Planning Commission Staff Report

File # 3S25 – SUB-000519-2025

**[Continued from July 8, 2025] Consideration of Approval for
Preliminary Subdivision Amendment to Create 4 Residential Lots
and a Private Lane Exemption Request on 1.42 Acres of Property
at 1280 W. Marinwood Ave. in Taylorsville, Utah.**

TO: Planning Commission
FROM: Ben White, City Engineer
DATE: July 16, 2025
RE: **3S25 – HALLIDAY ESTATES SUBDIVISION**

Exhibit B -

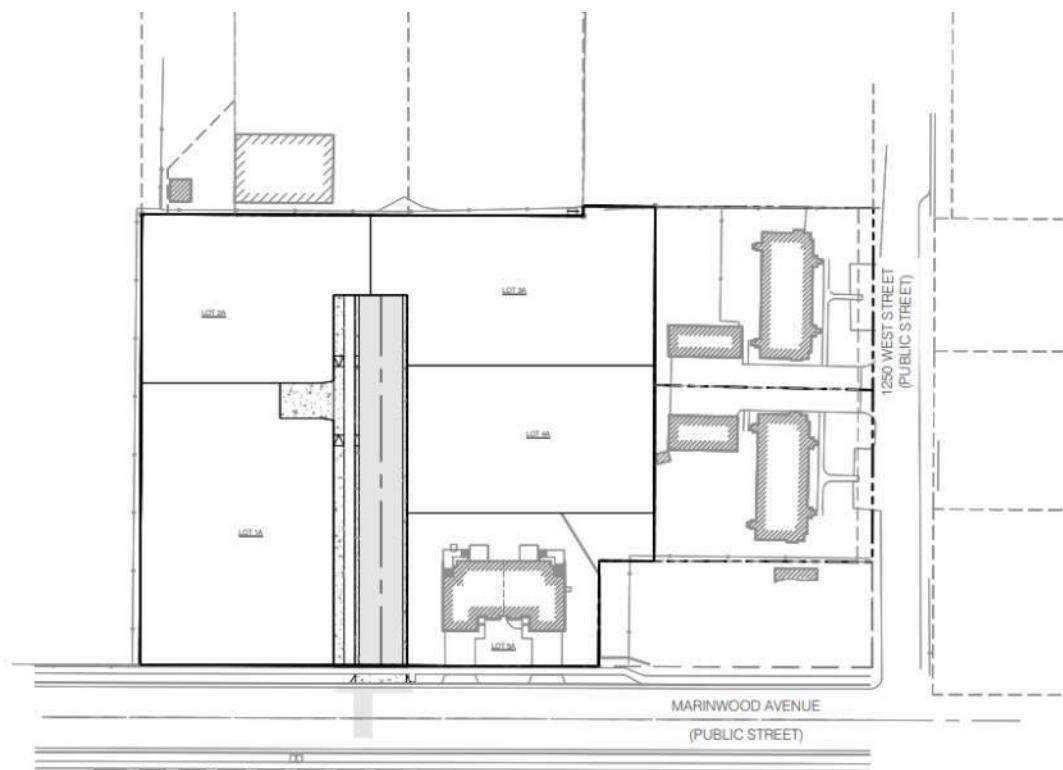
- Blue line shows a through street 800 feet to the west
- Orange line shows a through street 300 feet to the east
- Red box shows what the city proposes for a public street
- Purple Shadow shows the cities proposed through street
- Red X's show the structures that would need to be torn down just for the cities speculated through street.

Exhibit H

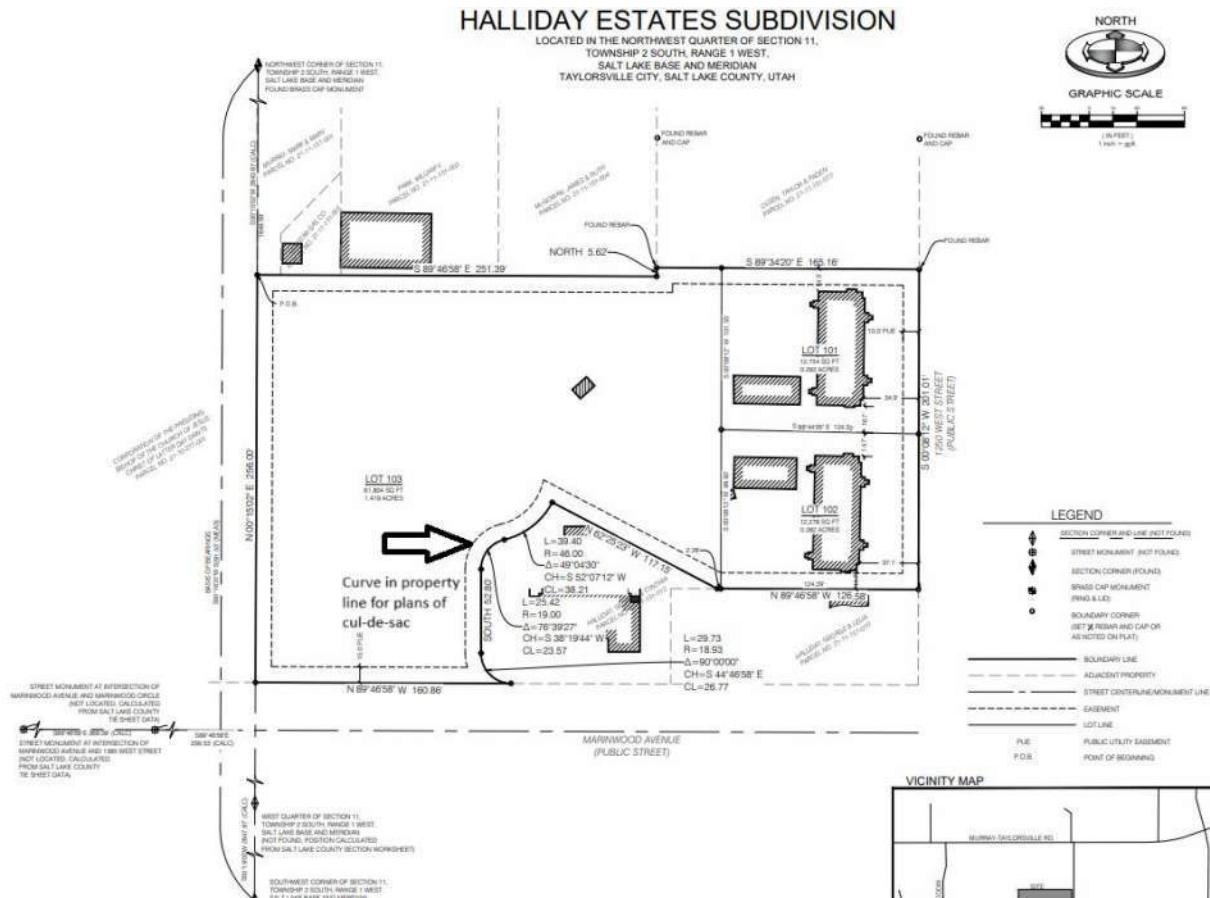
- See submitted document for Original Plans not marked
- Arrow points to the original property line due to plans of a cul-de-sac

Exhibit I

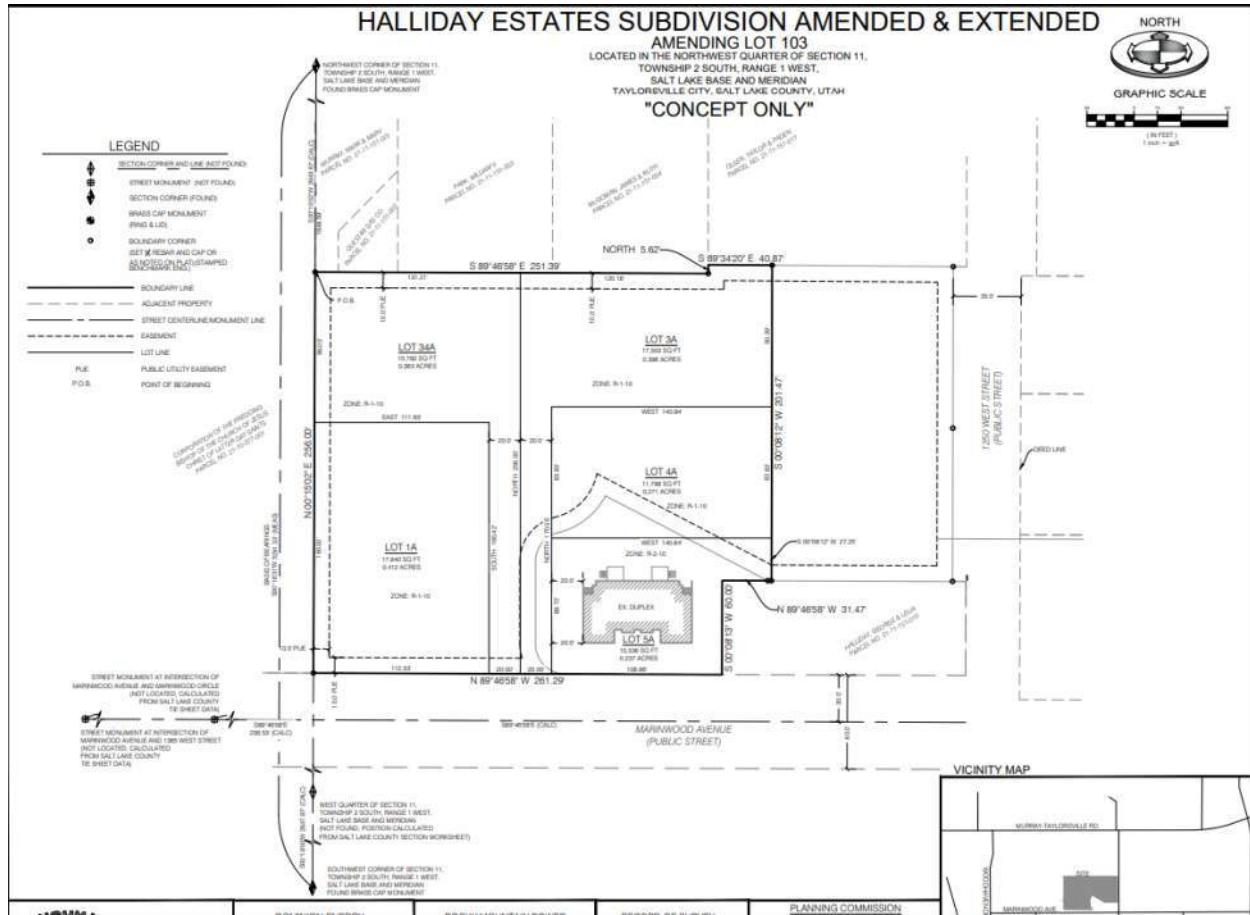
- Second Concept of development showing two shared driveways equaling 40' in pavement and 50' ROW which was denied by city

Exhibit J

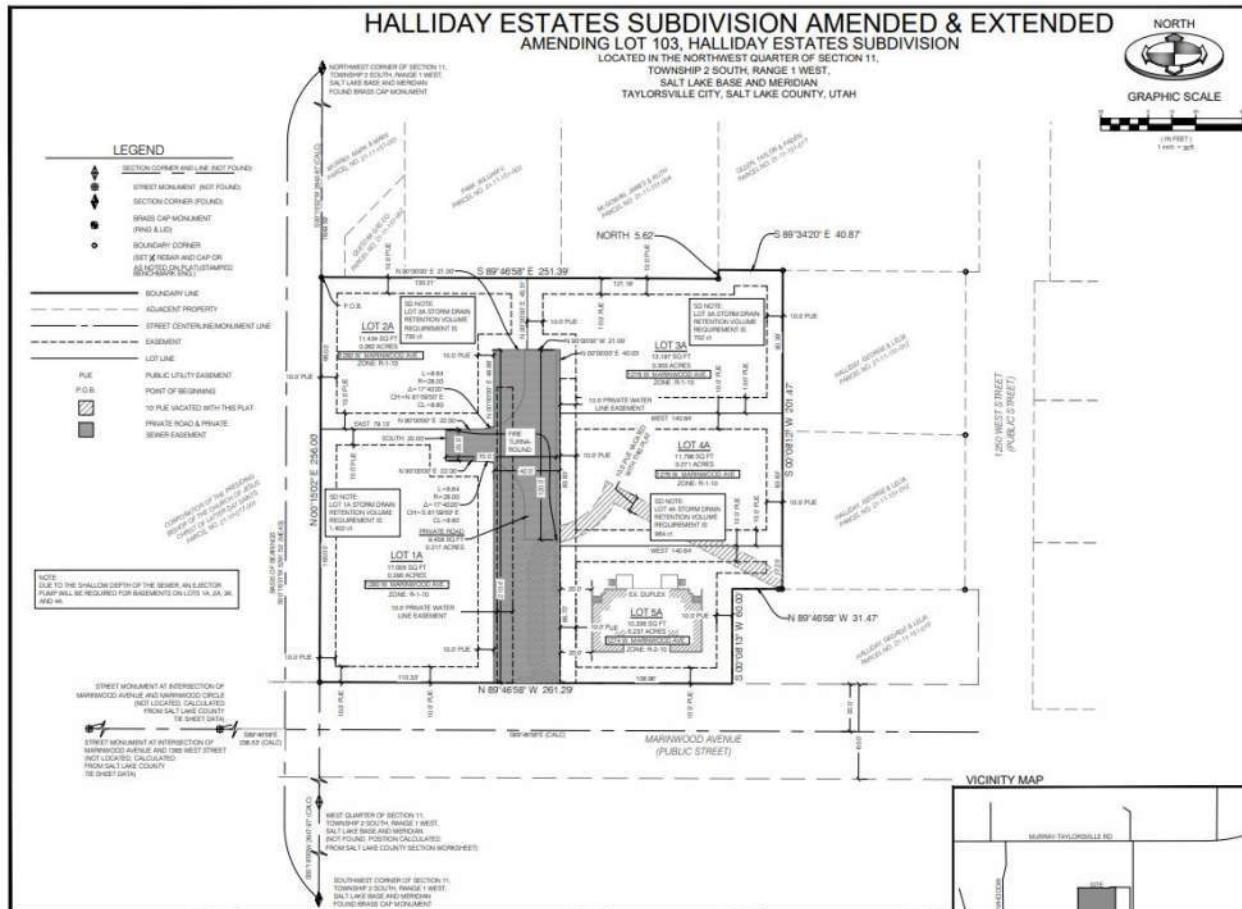
- Third Concept that was denied by city with statements that it needs to be a through road to the north end of property (statements in Exhibit K)
